**Bronx Community Board No.8, Environment and Sanitation Committee Meeting of January 3, 2023**

Bronx Community Board 8 comments on the NYNJHATS Tier 1 Feasibility Study

## **Bronx Community Board 8 Comments on the NYNJHATS Tier 1 Feasibility Study, for Submission to the NYNHATS Project of the USACE**

Figure 4 Tide Deck in Hudson River Park

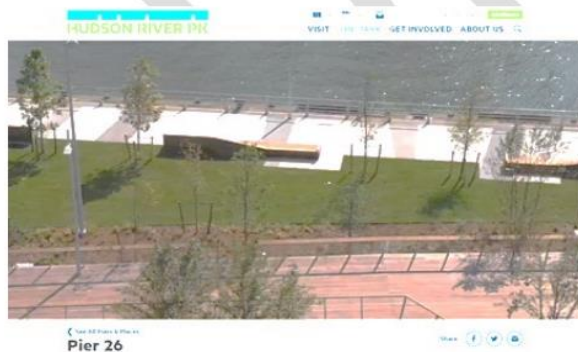
Furthermore, we have lost shoreline over the years, and it would be great to make up at least some of that. It's also worth noting that the best way to get a walking/bike connection between the Harlem River Greenway and the Hudson River Greenway would be a walkway extension over the water with green infrastructure and plant matter underneath. We considered something similar to this tide deck in Manhattan: <https://hudsonriverpark.org/locations/pier-26/>

Figure 2 NYS DEC Environmental Resource Mapper

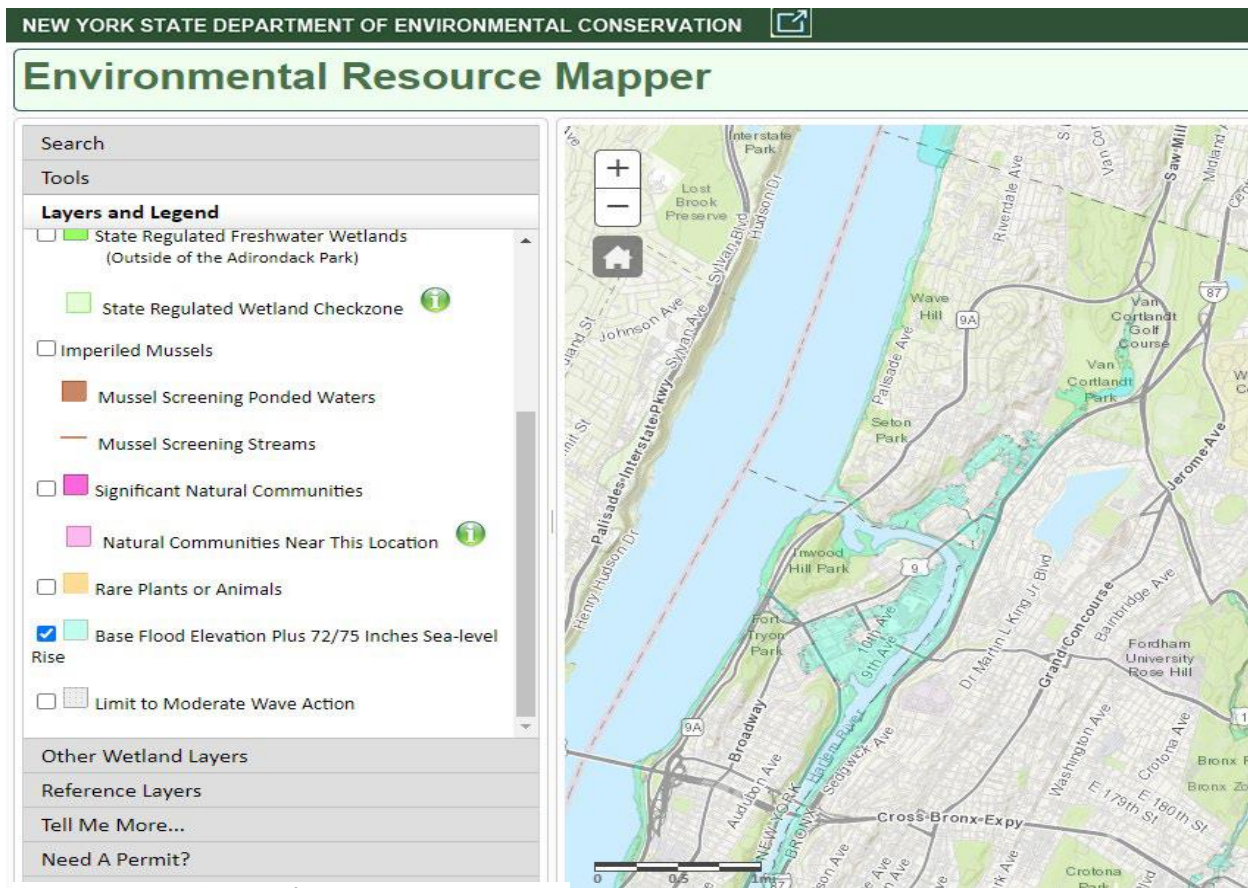
Development did not only come from the south. The built-up areas of the Tibbetts Brook watershed in Westchester County added to the extremely high-water table within Van Cortlandt Park. From work of the NY City Department of Environmental Protection, 65% of the water entering Van Cortlandt Park wetlands comes from Yonkers.

We are concerned that the mitigations discussed in the current version of the study will have a direct impact on Van Cortlandt Lake (a DEC protected fresh water wetland) once the daylighting project is completed due to blocking outfalls and increasing storm surge by directing more water north.

Figure 4 Tide Deck in Hudson River Park

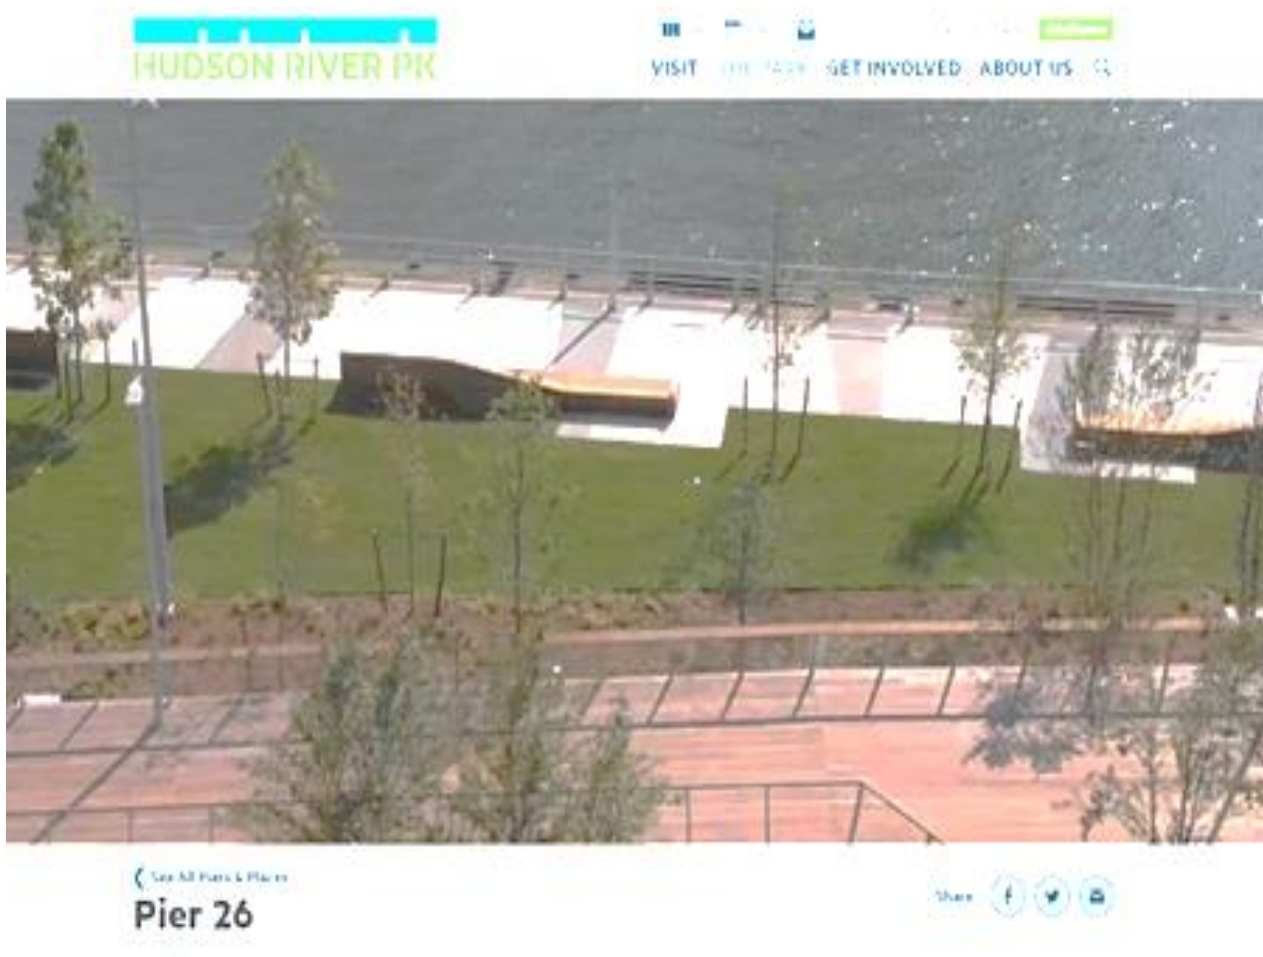
Furthermore, the Bronx lost shoreline over the years. It's also worth noting that the best way to get a walking/bike connection between the Harlem River Greenway and the Hudson River Greenway would be a walkway extension over the water with green infrastructure and plant matter underneath.

A project similar to this tide deck in Manhattan could be considered:
